Working paper No. EFV-09-02
(GRPE Informal Group on EFV,
9th Meeting, 15th February 2011)

OICA comments on EFV-08-02
Environment Friendly Vehicles
(EFV)

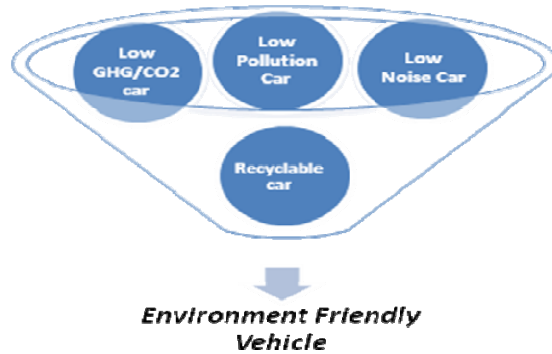
Comment [WPS3]: indicator recyclability is not supported as explained before by OICA. In the recyclability text changes are suggested to make that indicator more acceptable. This should be reflected in this figure
